## Valid for Emotron EMX P10 control unit for rotary heat exchangers

This is a supplement to the instruction manual for Emotron EMX-P10 with document number: 01-3092-01r3

### Activation of special software

Fig. 2 DIP switch

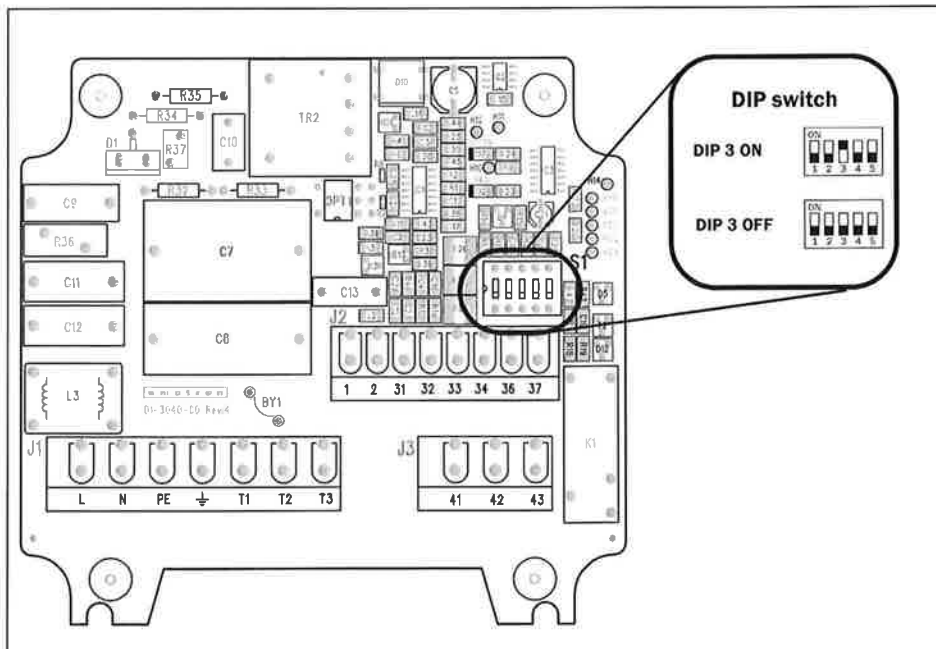
In installations with problems such as unpleasant smells during summer, there is now a solution. Instead of normal operation with purging it is now possible to run continuously at low speed and thus prevent odours.

The function continuous operation at low speed is activated by setting the DIP-switch 3, see Fig. 2.

- DIP 3 "OFF" means normal voltage or current input and normal operation with purging.
- DIP 3 "ON" means operation without purging, running continuously at low speed if the control signal is below 1.5 V.
